Addendum # 1 Bid Opportunity: 25-7748-RFT - St. Andrew's Public School 3rd Floor Classroom Refinishing Closing Date: Wednesday, May 21, 2025 2:00 PM

Addendum #1

Project: WRDSB St Andrews, 65 Victoria Avenue, Cambridge, ON N1S 1X2

Project No.: 22988

SHEET NO: A051

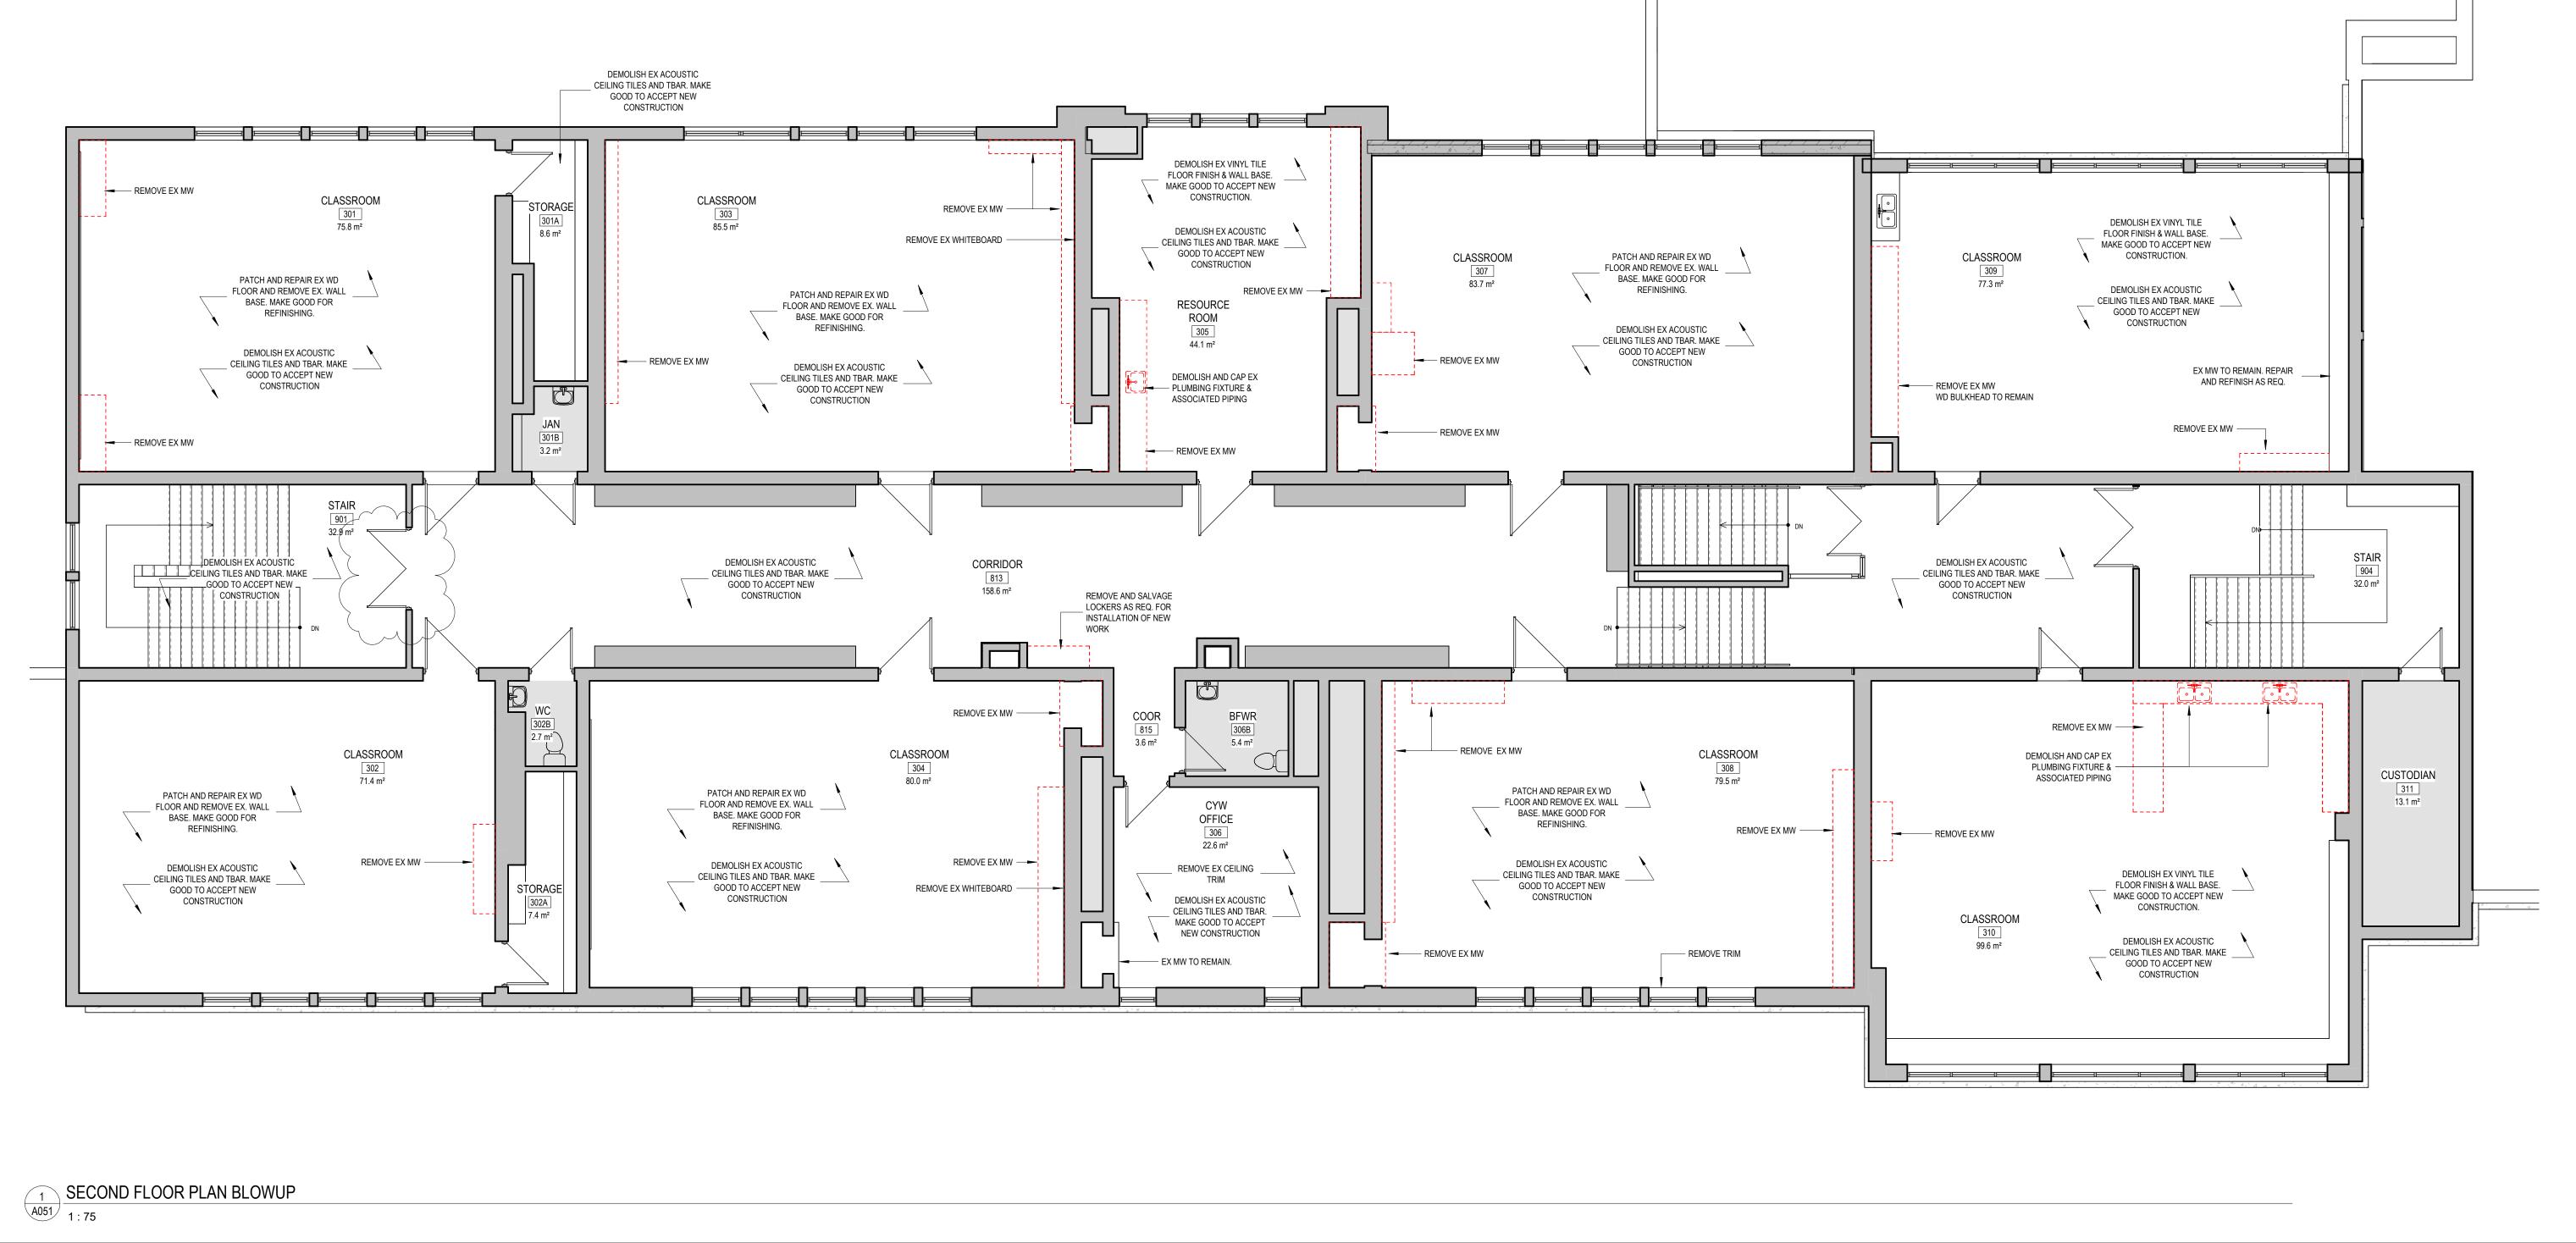
In drawing A051, it is requested to demolish the wall in the area called Stair 901. However, in drawing A101, there is an existing door in the same location. Which instruction should we follow?

DELETE A051 Second Floor Demolition, dated 05/02/2025; **ADD** in lieu Drawing A051 Second Floor Demolition, issued here, dated 05/12/2025; REVISIONS:

- Remove demolition of door in stair 901;

Answer 1:Drawing Error – corrected – see attached reissued Architectural Drawing A051;
